737

Service Bulletin

Number: 737-28A1206
Original Issue: January 11, 2006
Revision 2: May 21, 2009
ATA System: 2822 3152

SUBJECT: FUEL - Distribution - Center Fuel Tank Boost Pump Auto Shutoff and Master Caution Logic Change

This Figure applies to Group 5, Configuration 1; Group 6, Configuration 1; Group 7, Configuration 1; Group 8, Configuration 1; Group 9, Configuration 1; Group 10, Configuration 1; Group 11, Configuration 1:

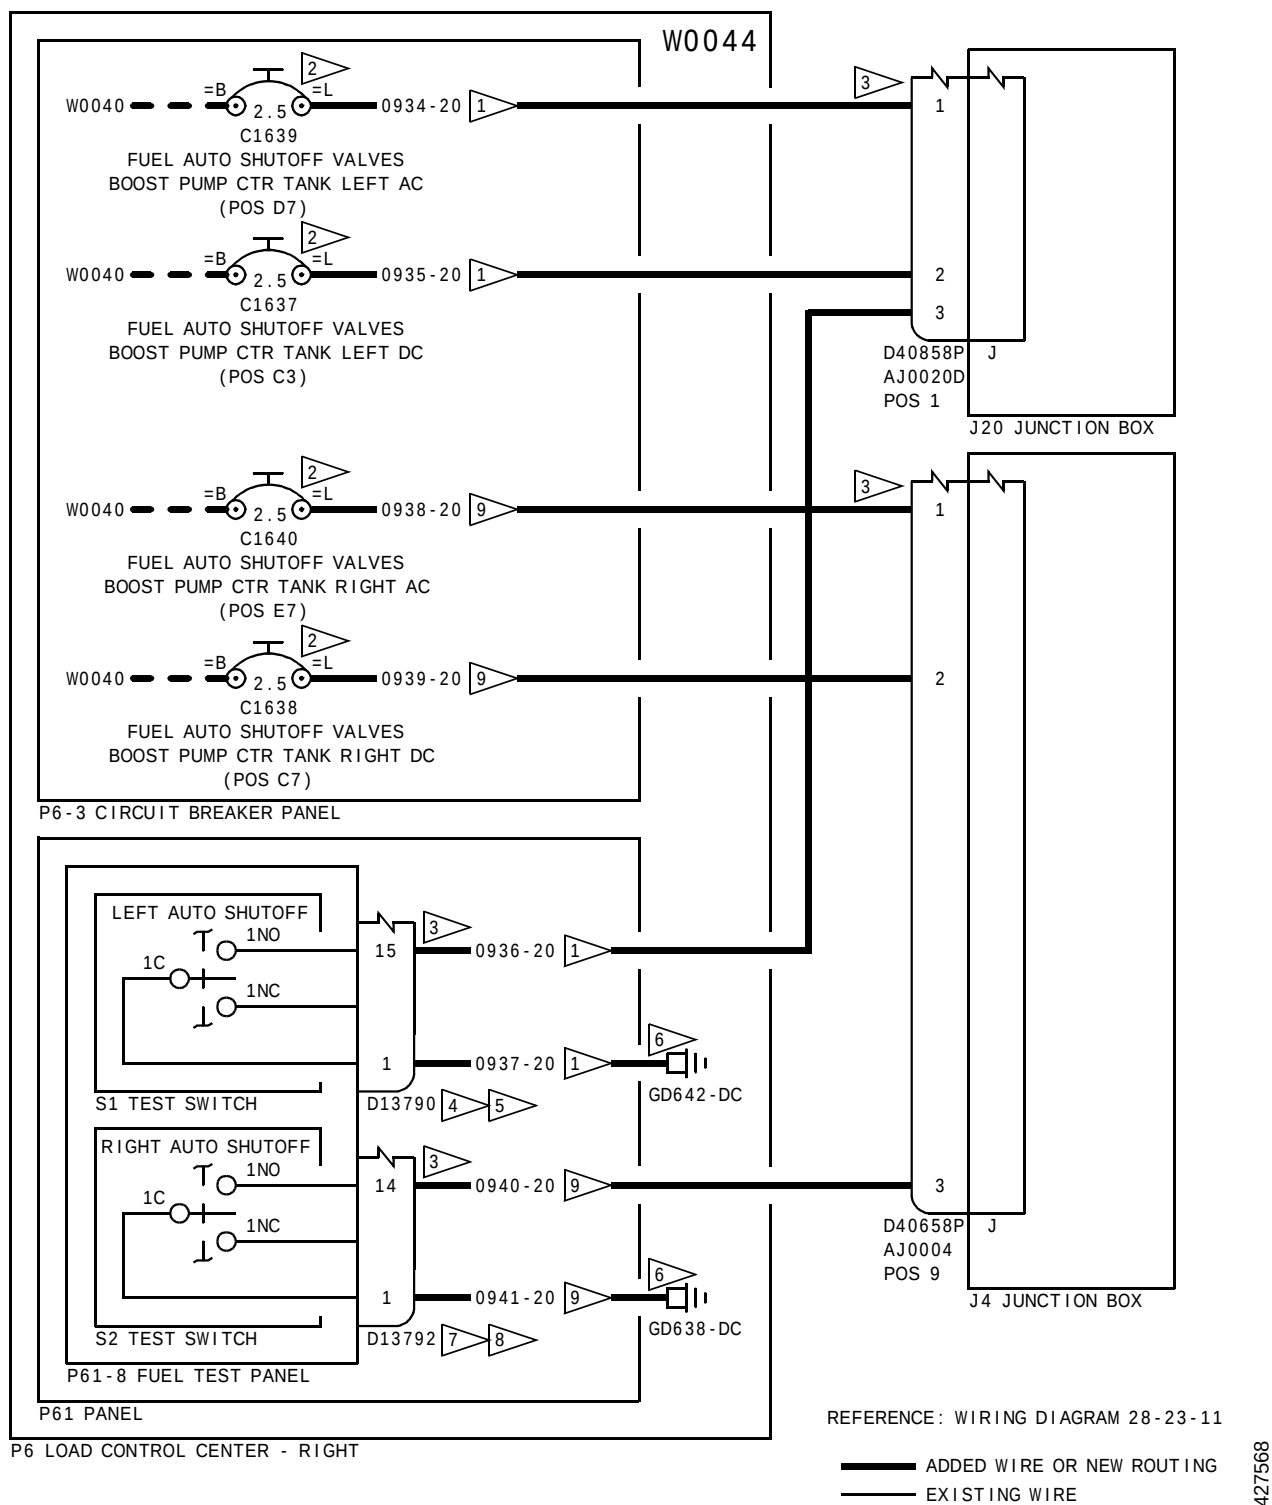
Changes are made to Figure 39 to show the route of wire bundle W0044 to the P6-3 circuit breaker panel. The Figure effectivity is changed to remove the Group 12 airplanes.

FIGURE 41: W2112 WIRE BUNDLE ROUTING

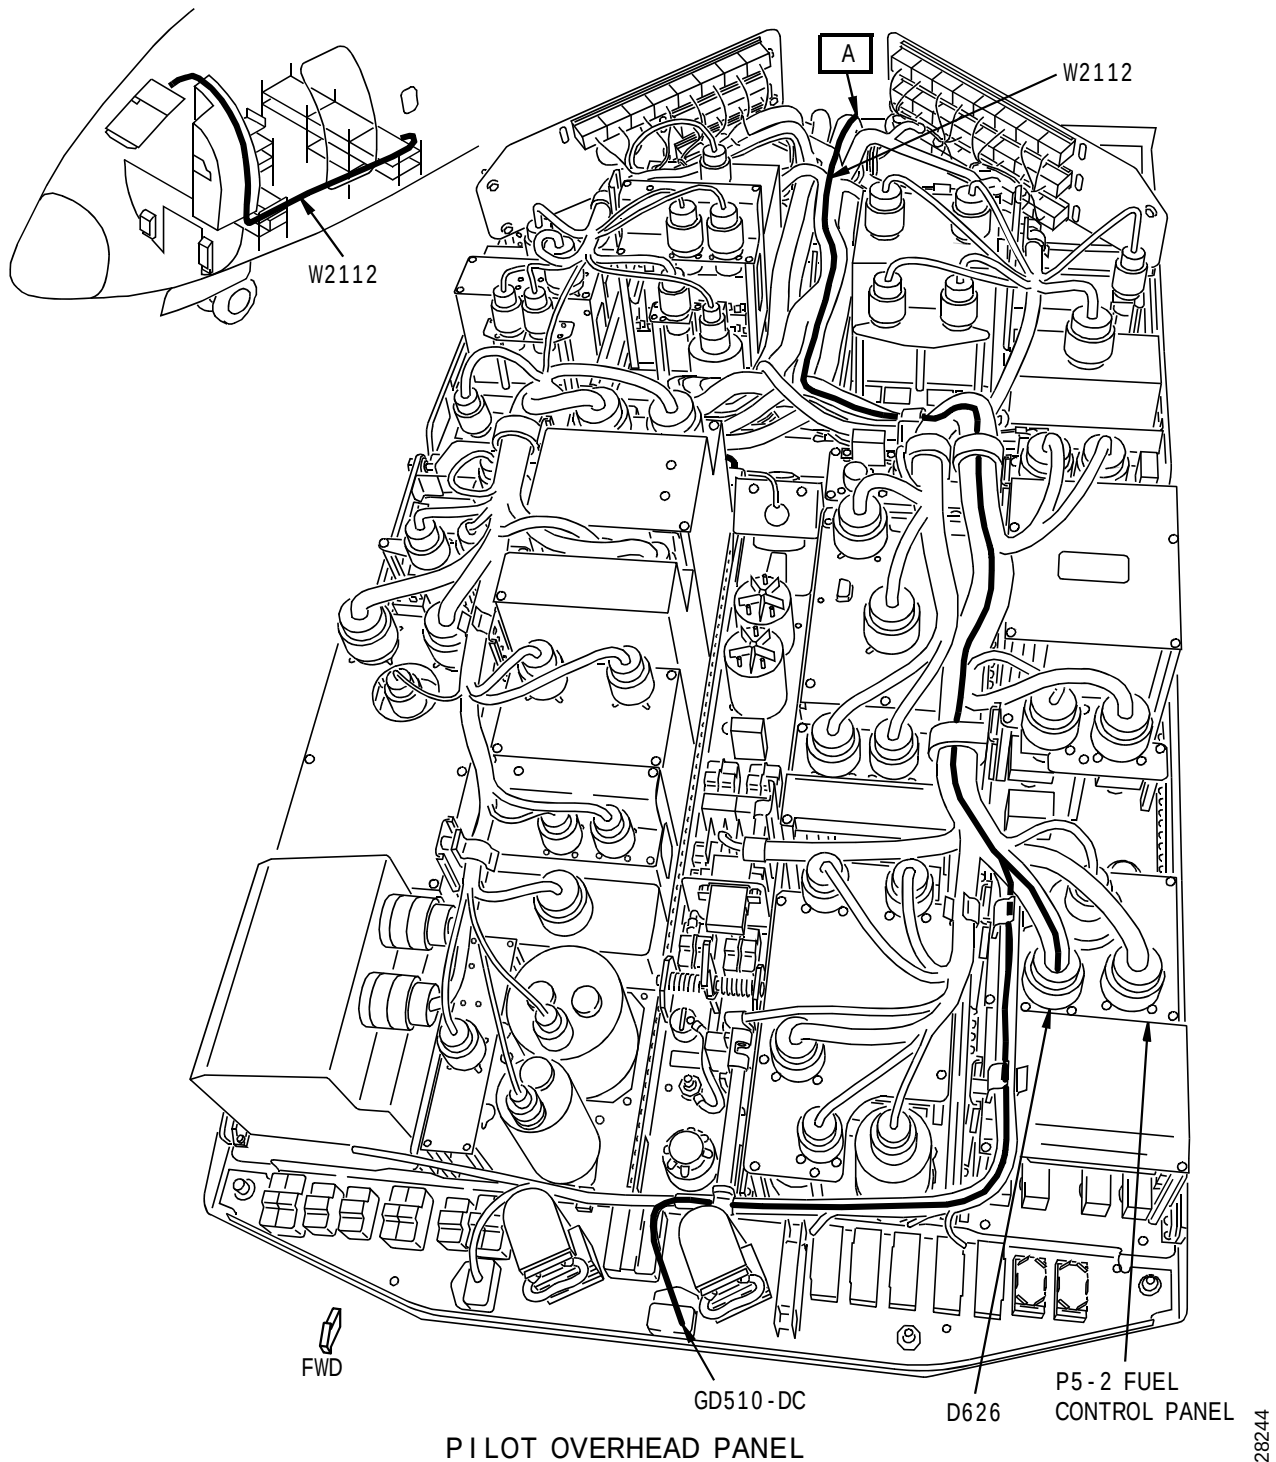
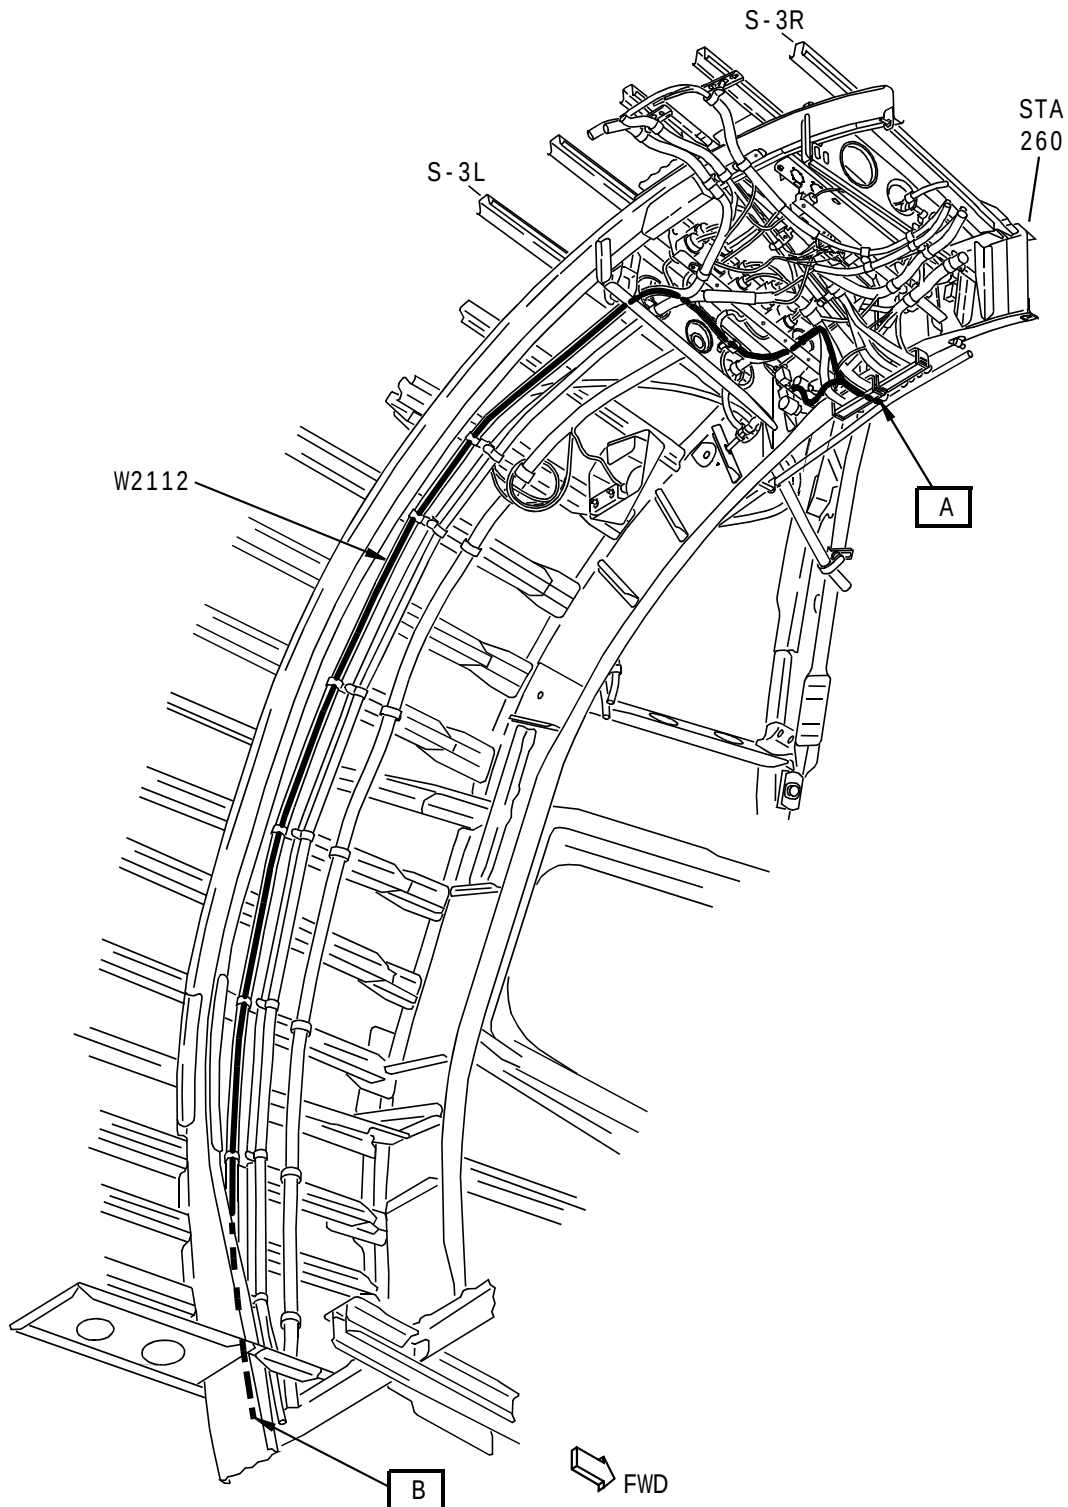
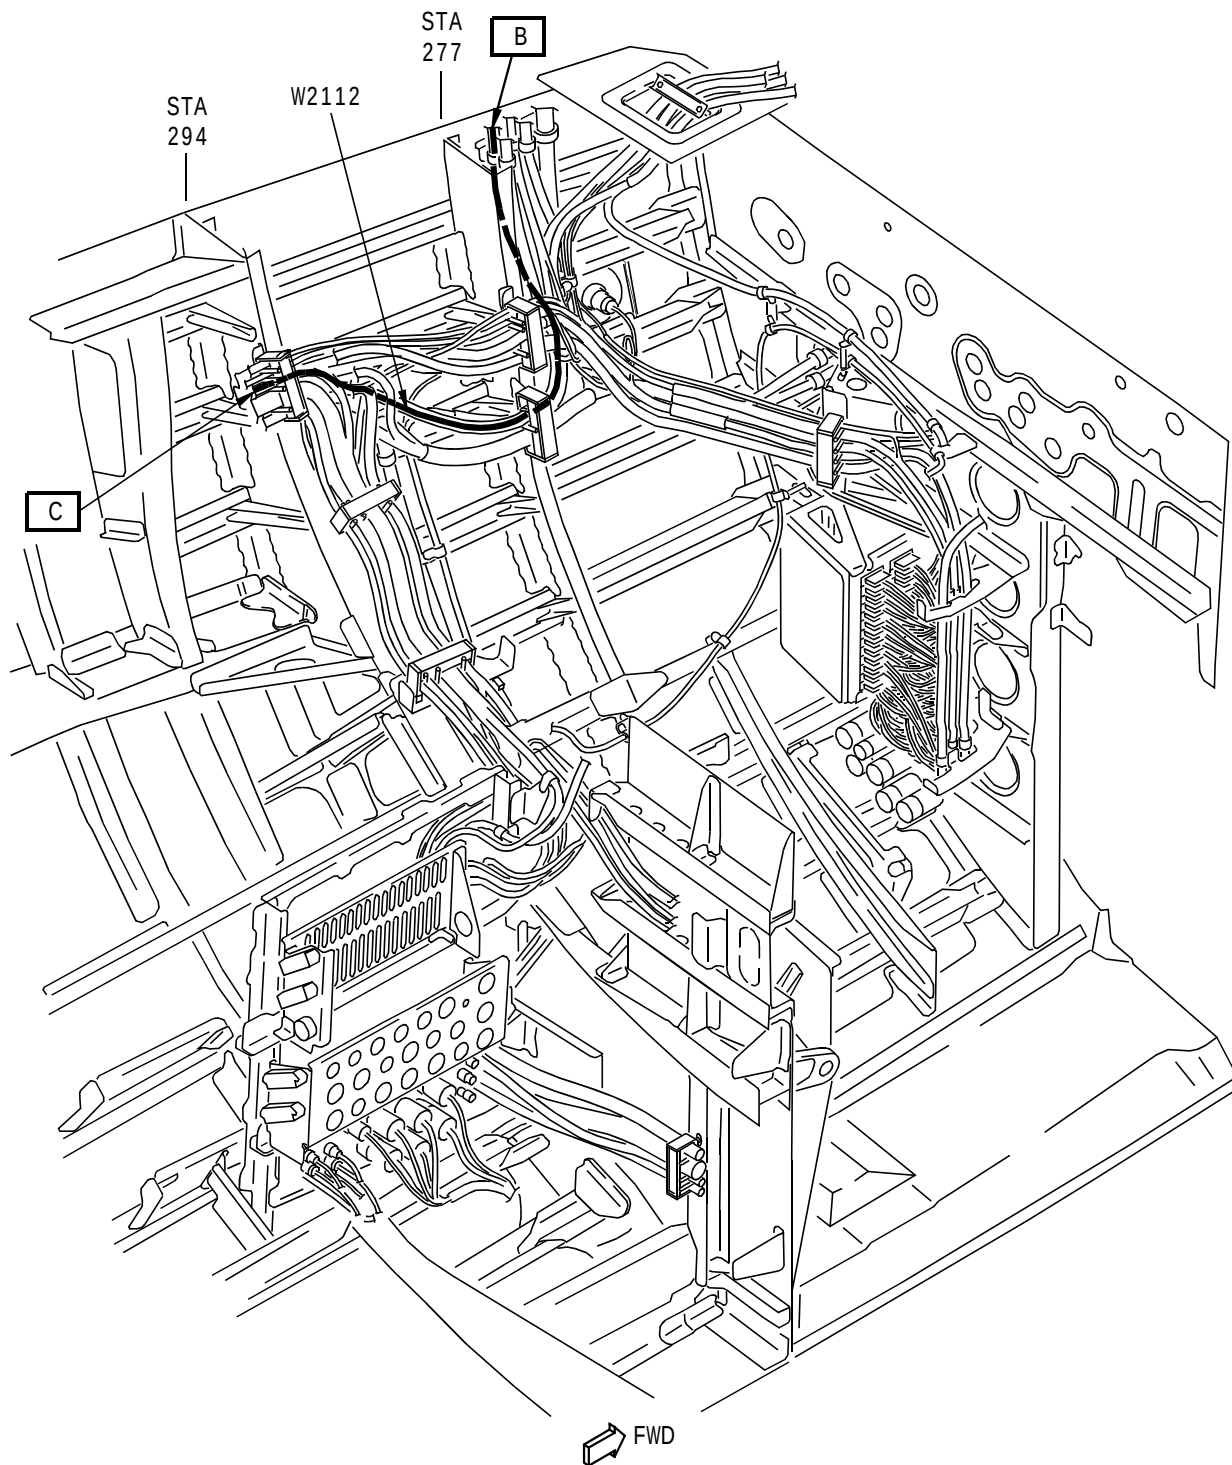
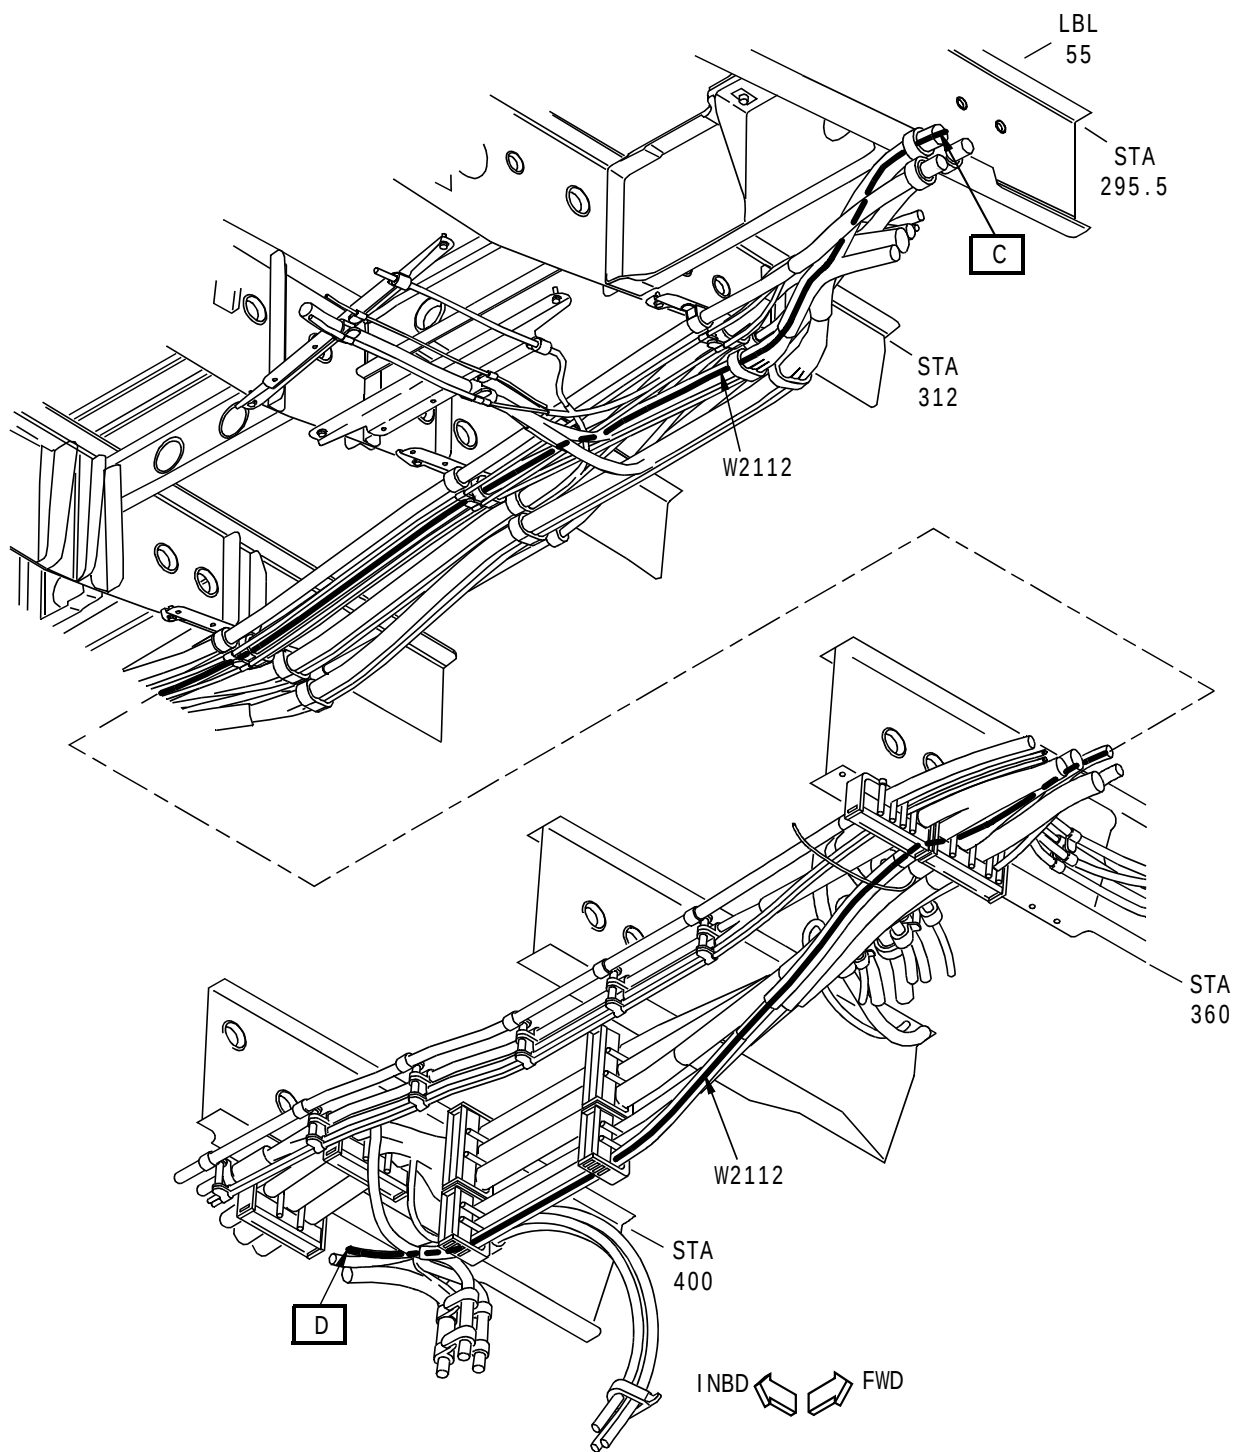
Changes are made to Figure 41 to correct the route of wire bundle W2112 and to add a title to the Figure to clarify the location shown.

FIGURE 43: WIRE BUNDLE W0212 AND W2112 WIRING CHANGE

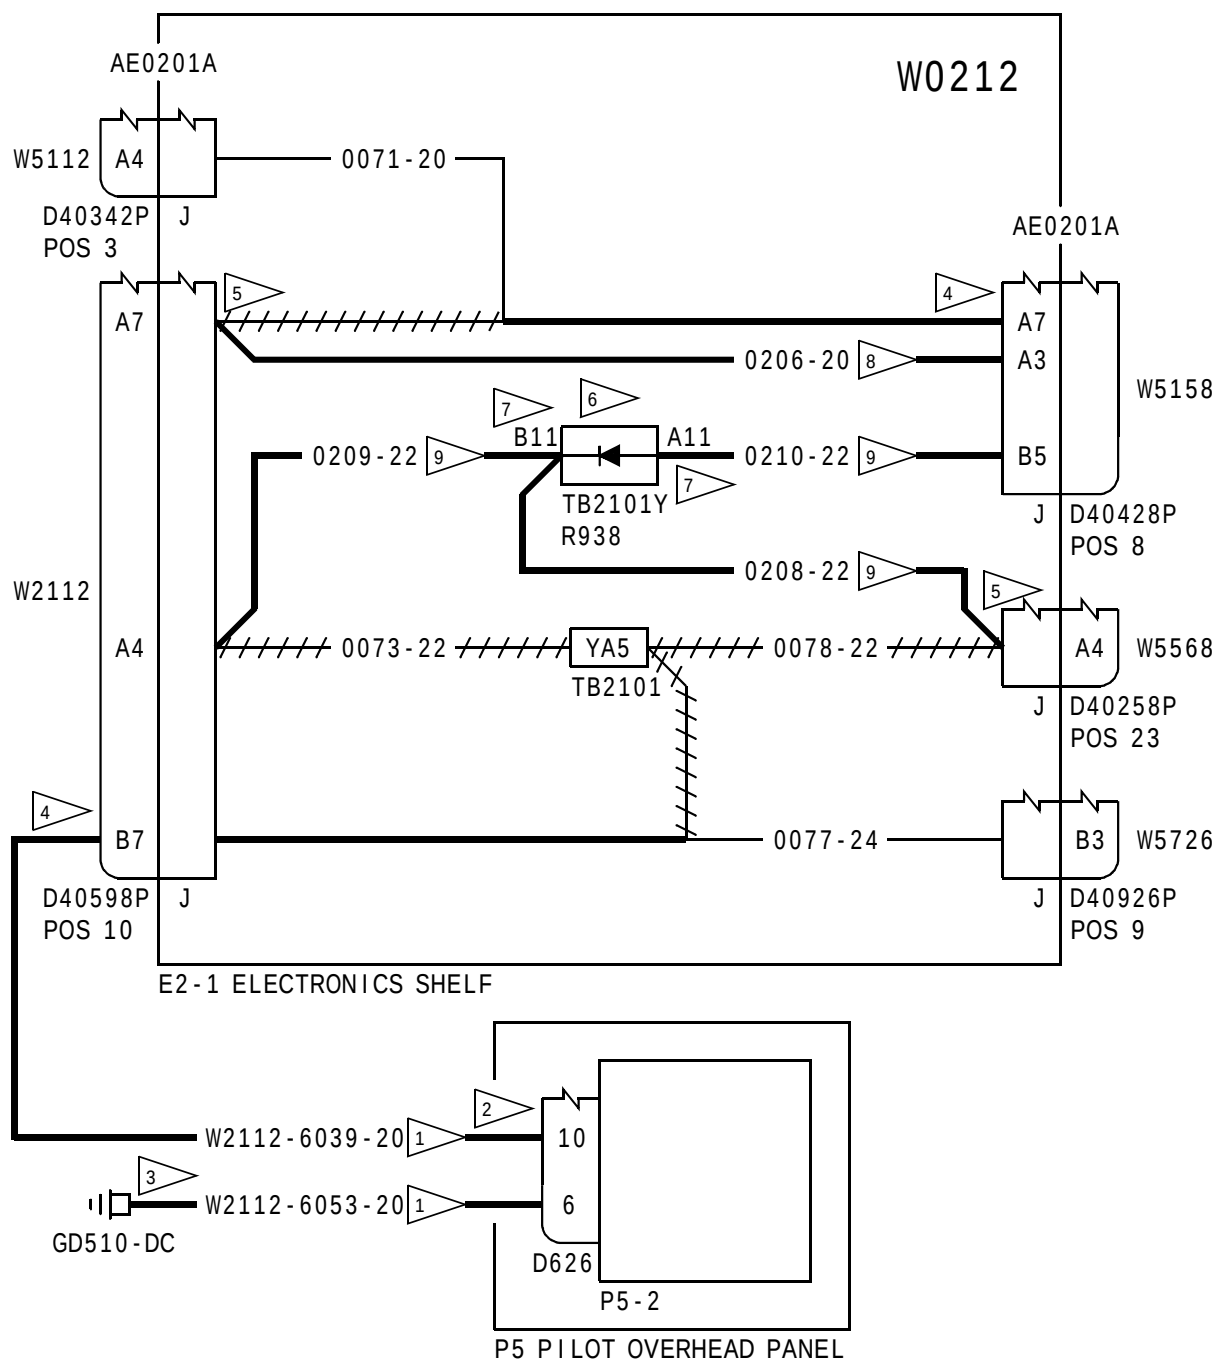
Changes are made to Figure 43 to change Socket Contact part number BACC47CP1A to BACC47CP1S.
